2019:24

SSM's external experts' review of
SKB's analysis of long-term safety of
1BMA (SFR)

Reference: SSM2013-4854

Review of SKB's analysis of long-term safety of 1BMA (SFR)

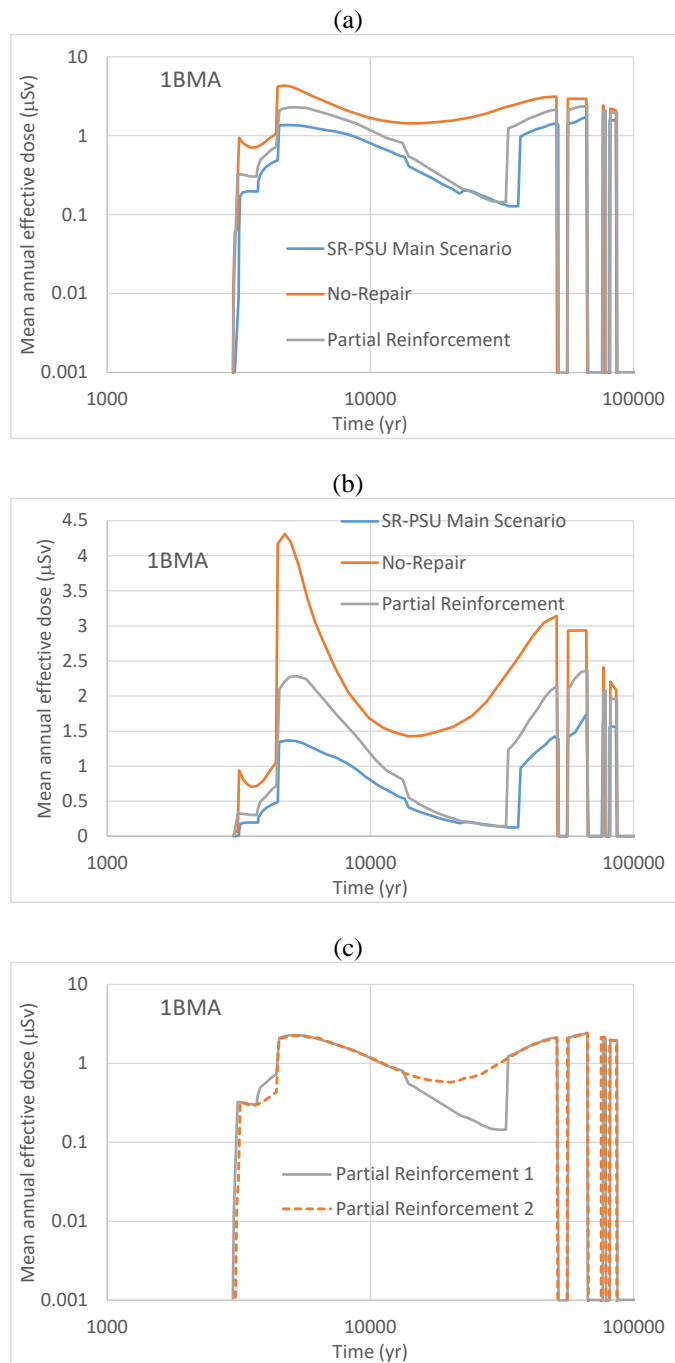
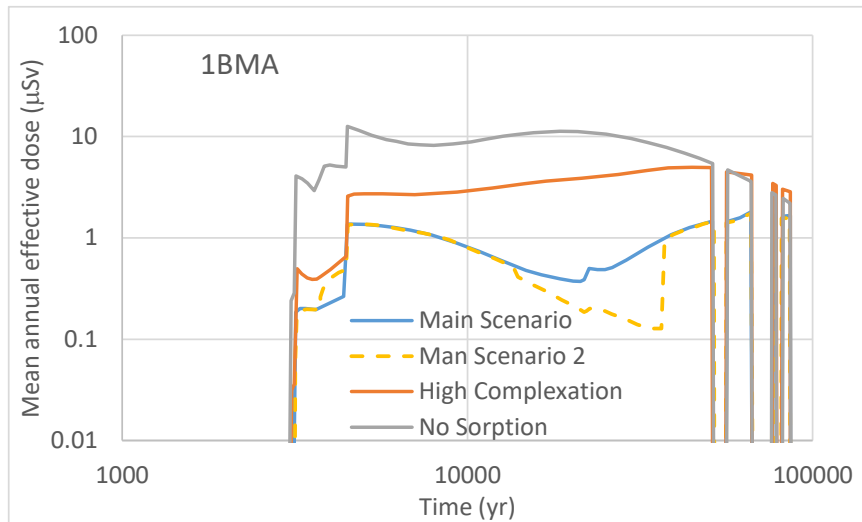
It is not clear why different mean annual effective doses are associated with the same cases [see Figure 1(c), Partial Reinforcement Case, and Figure 8, Main Scenario, in this report]. We recommend a clarification question to SKB to address this minor issue.

In addition, SKB should clarify the reason for two different sets of mean annual effective dose for 1BMA [blue and yellow dashed curves in Figure 8 for the Main Scenario, and the two curves in Figure 1(c) for the Partial Reinforcement Case]. It appears that SKB applied some smoothing between 13,000 and 37,000 years, but we have not found any mention of smoothing in the SKB documents. Although the apparent smoothing does not affect peak dose estimates and the overall SKB conclusions, a technical basis is pertinent to avoid confusion.

We recommend seeking a clarification on reasons for reporting different mean annual effective doses for the same cases in the TR-14-09 and the injunction response document [see Figure 1(c) and Figure 8 in this report].

Figure 3. Flow rates SKB computed using a COMSOL model. The data source for this plot is Figure 5-3 of the injunction response document (SKB, 2018). Noted K values are for the Main Scenario, and for all concretes except the base slab in the Partial Reinforcement Scenario.

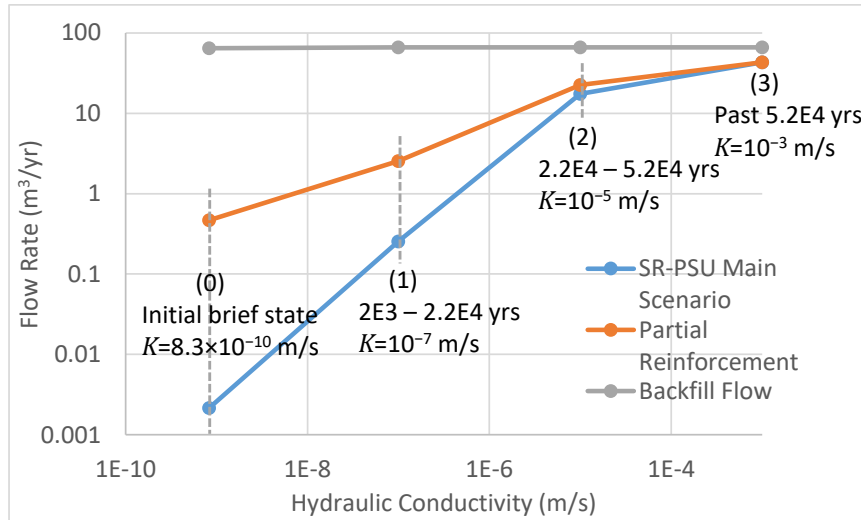
SKB computed volumetric flows along six different directions for each waste compartment. Each flow rate was, most likely, computed by SKB by integrating the water flux projected along the normal direction of the six faces of each waste compartment. SKB was not specific with regard to what was represented by the flow rate in Figure 5-3 (SKB, 2018, Figure 3 in this report) (Is it an average flow over all directions and all compartments? Is it a maximum flow? What is the relationship of the flow to radionuclide transport computations?) Nonetheless, we consider a factor of 10 change in flow by changing the base slab hydraulic conductivity from 10^{-7} to 10^{-5} m/s [Figure 3, label (1)] to be reasonable.

In the SKB Main Scenario computation (Figure 3), the flow rate increased by almost two orders of magnitude when the concrete hydraulic conductivity increased from 10^{-7} to 10^{-5} m/s. In the Partial Reinforcement Case, the increase in flow was only approximately a factor of 10. Those changes are comparable to changes from the Partial Reinforcement flux curve to the No-Repair flux curve in the new computations shown in Figure 6. In the No-Repair Case, we assumed concrete $K = 10^{-5}$ m/s, and waste form $K =$ base slab $K = 10^{-3}$ m/s (other hydraulic conductivities were the same as the Partial Reinforcement Case). The maximum change in the magnitude was approximately a factor of 30 between these two cases. As previously stated, the intention was not reproducing the SKB computations, but to obtain some insight into the potential flow response in 1BMA to changes in hydraulic conductivity.

Finally, the increase in flow in both the Main Scenario and Partial Reinforcement curves in Figure 3 was approximately a factor of two when the concrete hydraulic conductivity increased from 10^{-5} to 10^{-3} m/s. Such increase is comparable to the increase in flux from the No-Repair Case to the Fully Degraded Case in Figure 6. In this latter case, we assumed $K = 10^{-3}$ m/s for the concrete walls, concrete lid, base slab, and waste form.

For the case of 1BMA without repair, SKB assumed an initial hydraulic conductivity of the concrete of 10^{-5} m/s . From Figure 3, label (2), the initial flow rate for that case is approximately $23 \text{ m}^3/\text{yr}$, which is almost two orders of magnitude greater than the initial flow in the Main Scenario. SKB computed a peak dose equal to $4.2 \text{ } \mu\text{Sv}/\text{yr}$ for the No-Repair Case, which is only a factor of 3 greater than the Main Scenario peak dose (Table 4-2, SKB, 2018). As explained in the previous paragraph, the increase in the dose estimate is not necessarily linearly related to the increase in flow rates. In addition, detailed actual flow rates used in the radionuclide release and dose computations are not provided in SKB documents. Actual flow rates may differ by less than two orders of magnitude. Those two factors may be sufficient to explain why the peak dose estimates increased only by a factor of 3 from the Main Scenario to the No-Repair Case.
